TECHNICAL NOTE

Date: 7th December 2018

Project: Cinders Farm – Traffic and Transport Matters

- 1.1 This Technical Note (TN) has been produced by SK Transport Planning Limited in response to Wrexham Council's traffic and transport comments on Planning Application P/2018/0577 relating to the erection of four agricultural buildings and plant, associated infrastructure, landscape and access arrangements. The development proposes to deliver a new poultry farm scheme at the farm, as part of a farm diversification programme.
- 1.2 The Council's formal traffic and transport comments issued on the 28th August 2018 are appended to this letter for information in **appendix a**. In addition, a site visit with the Council's Highways Officer took place on the 8th October 2018.
- 1.3 The development proposals were also subject to pre-application discussions, and at the time the Council's Highways Officer commented as follows:

Cinders Farm Visibility Splay Calculations 01/12/2018

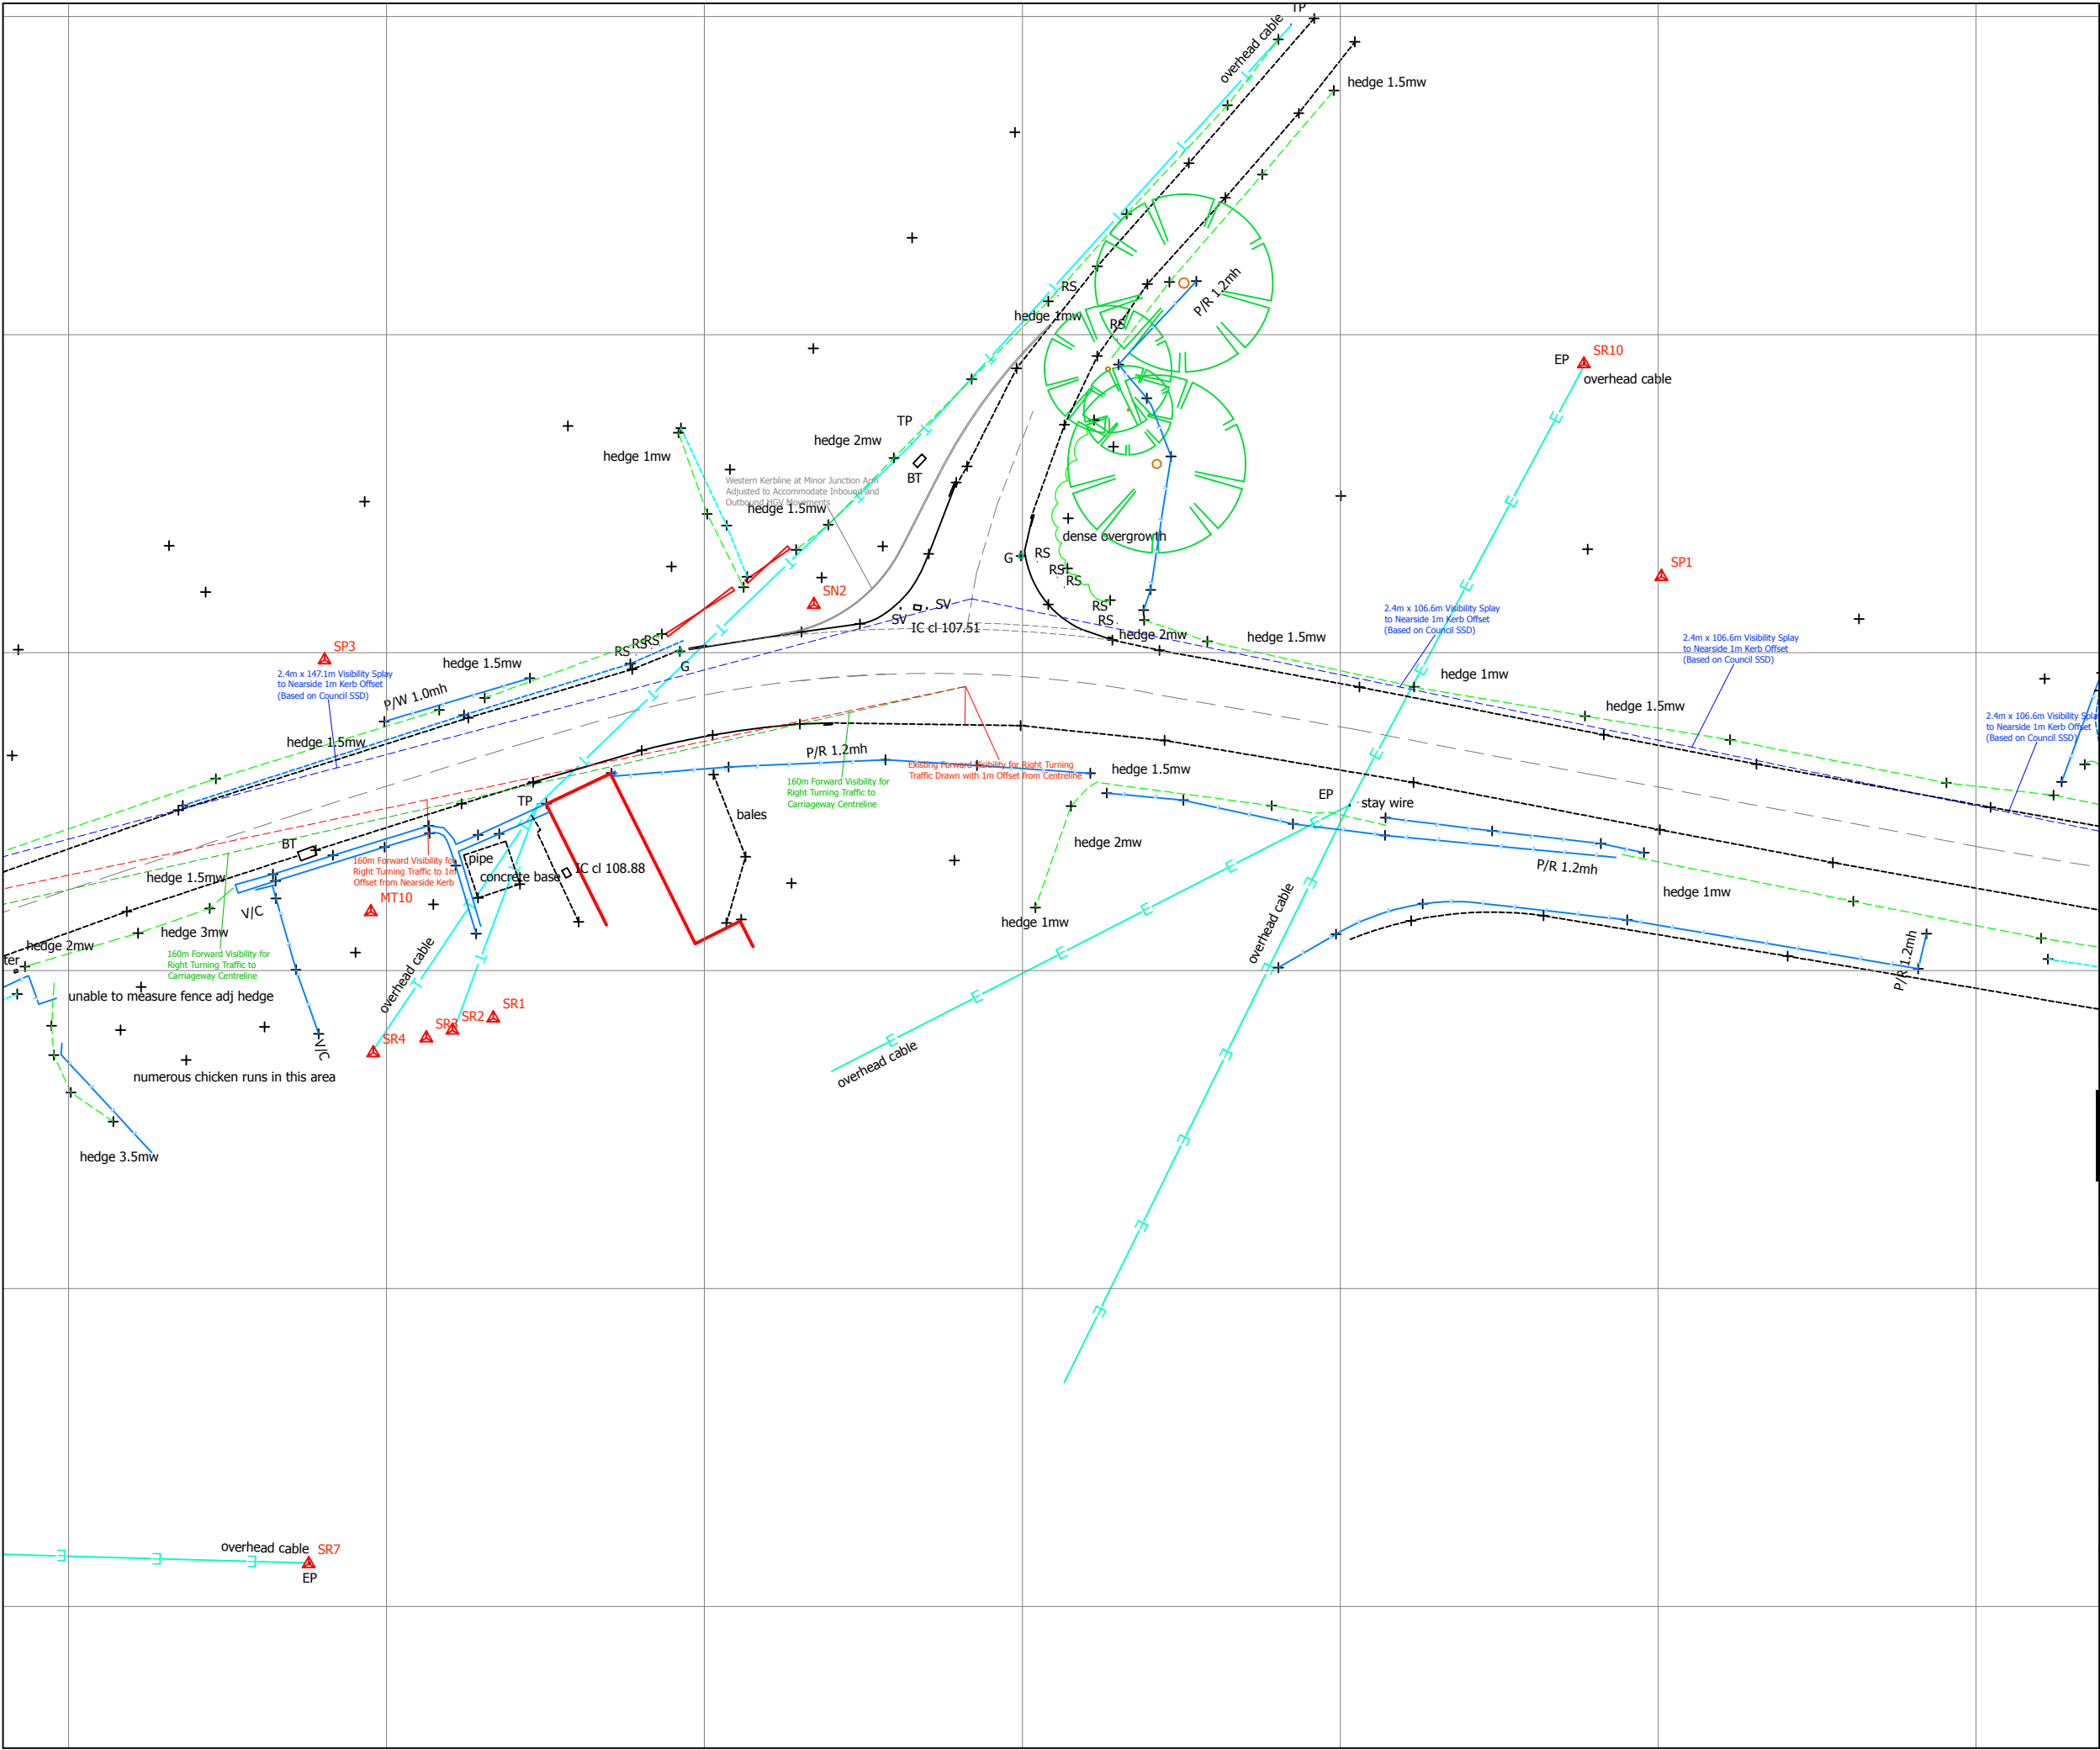
- 1.10 The Council's formal response has indicated that with the A539 having a speed limit of 50mph they expect visibility splays at the simple priority junction where Cinders Lane meets the A539 to be 2.4m x 160m in both the leading and trailing traffic directions. We note that the Council's response highlights that these visibility splays should be delivered as part of "any proposed access/junction", but of course the development proposals are utilising an existing simple priority junction and lane that forms part of the publicly adopted highway to access the farm. Both the junction and Cinders Lane have been shown to have no adverse personal injury collision record over the last five years.

- 1.11 Notwithstanding the above position opportunities to enhance the visibility splays at the simple priority junction onto the A539 have been recommended by the Council and considered in this response. To inform the assessment the Council has provided directional traffic flow and speed survey data for the A539, which has confirmed the 85th percentile speeds on this route are:

- 1.12 Note that no adjustment has been made to this speed survey data to reflect wet weather speeds on this route.
- 1.13 Using this directional speed survey data and the guidance contained in Manual for Streets the appropriate "Y" distance visibility splay dimensions have been calculated. The visibility splay calculations are presented in **appendix b**, and are based on the following assessment parameters:

- 1.14 The calculations presented in **appendix b** confirm that based on the Council's own speed survey data the following visibility splays should be provided at the Cinders Lane/A539 junction:

- in the leading (western) traffic direction, visibility splays of 2.4m x 147.1m
- in the trailing (eastern) traffic direction, visibility splays of 2.4m x 106.6m

SK21685-09 REV A

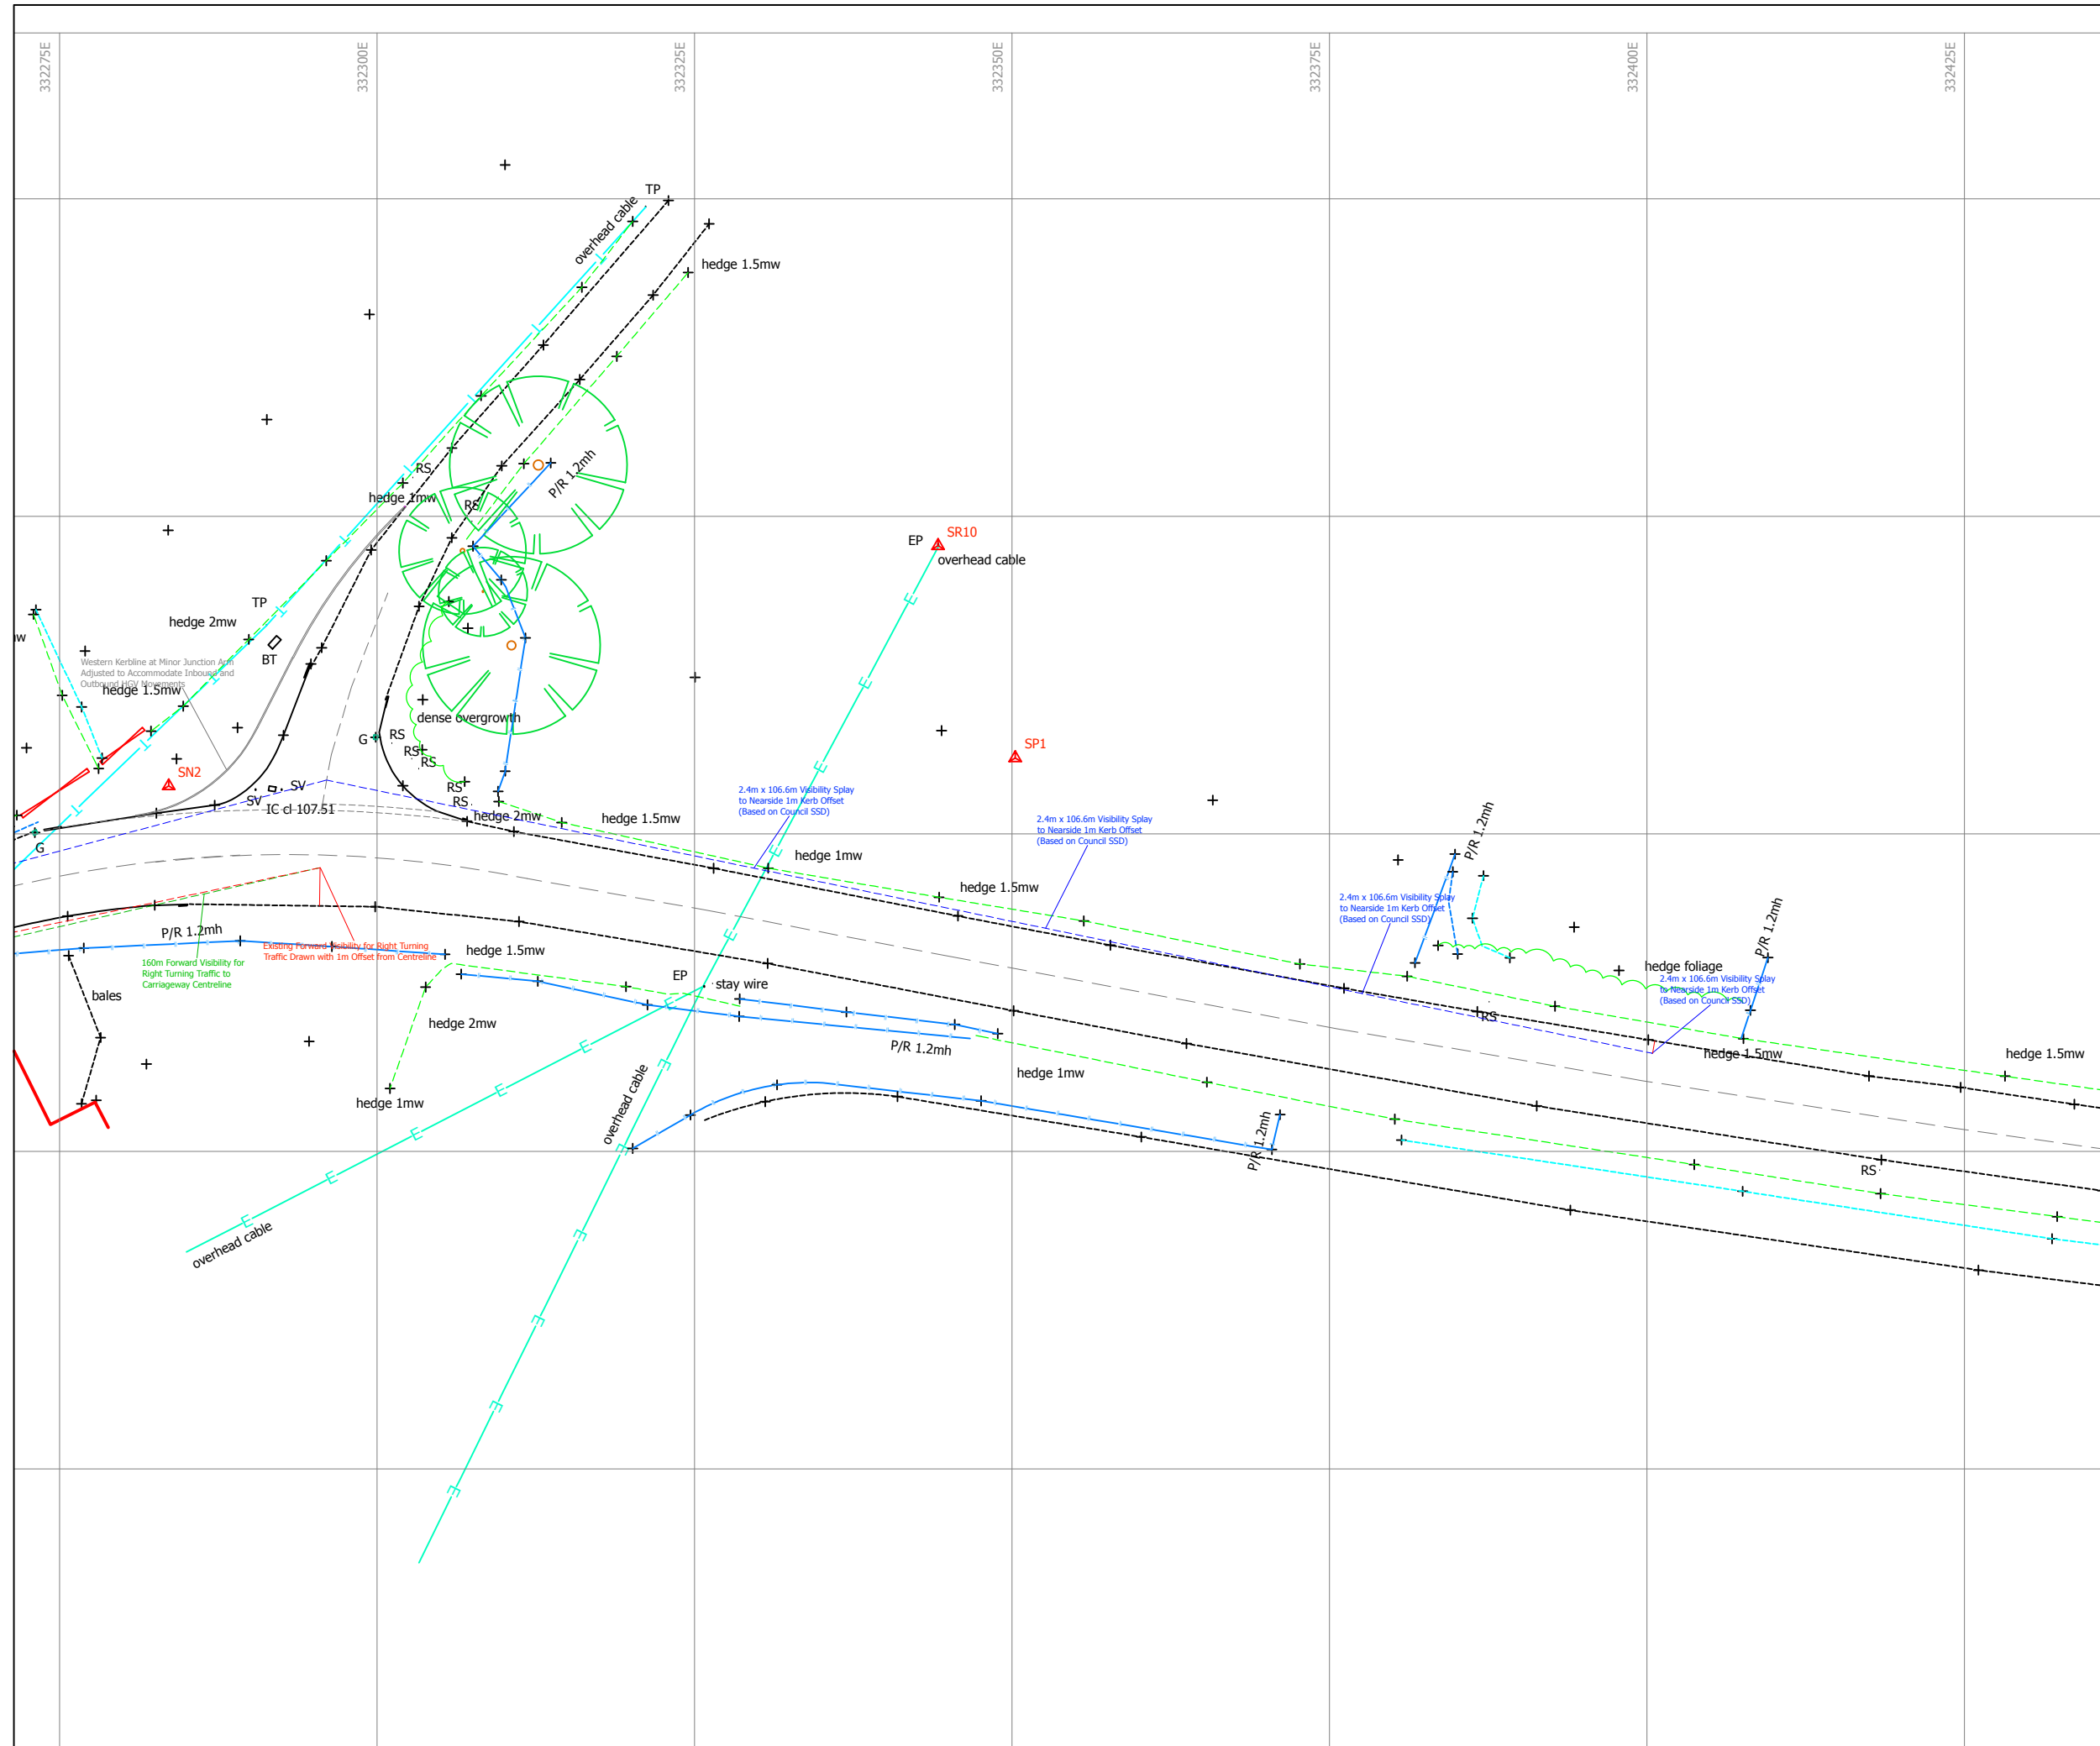
Visibility from the existing junction onto the A539 is currently inadequate in both directions. Visibility in the westerly direction is approximately 2.4 x 120m measured to the nearside edge of the adjoining highway. Visibility is impeded by the existing hedgerow and I assume any improvements would require work on 3rd party land. Visibility in the easterly direction is inadequate providing a splay of approximately 2.4 x 30m measured to the nearside edge of the adjoining highway. Visibility is impeded by the existing hedgerow along this section. I understand that the applicant is offering to improve visibility in this direction and provide a splay of 2.4 x 120m measured to the nearside edge of the adjoining highway. I assume that the applicant has control of this land in order to deliver this improvement.

Any proposed junction in this location would also normally be required to provide adequate forward visibility between vehicles waiting to turn into Cinders Lane and vehicles approaching from the west providing a stopping sight distance (SSD) of 160m. Forward visibility in this location is approximately 90m being impeded by the existing building on the bend belonging to Wynnstay Stables.

Forward visibility splays have not been indicated on the submitted layout plan. **I would recommend that the applicant provides this information on a revised layout plan.**

- 1.15 These visibility splays have been overlaid onto a topographical survey, as suggested by the Council's Highways Officer at the site meeting. The splays have been drawn with a 2.4m "X" distance setback and the "Y" distances as presented above. The splays have been drawn with a 1m offset from the nearside kerb, to deliver appropriate intervisibility between a vehicle waiting on the minor junction arm and a vehicle approaching from the eastern and western traffic direction. The drawings are presented in **appendix c**.
- 1.16 The drawings confirm that with management of the hedges on either side of the minor junction arm it is possible to deliver these visibility splays in perpetuity. The splays are confirmed to cross land the applicant controls or the publicly adopted highway, and offer a material betterment for all

- 1.17 The Council has also requested an assessment of the achievable forward visibility for vehicular traffic turning right from the A539 into the existing rural lane that is used to access Cinders Farm. The drawings presented in **appendix c** confirm that using a 1m offset from the carriageway centreline to reflect the position of a motorist in a vehicle turning right into the minor junction arm it is possible to achieve 160m forward visibility.
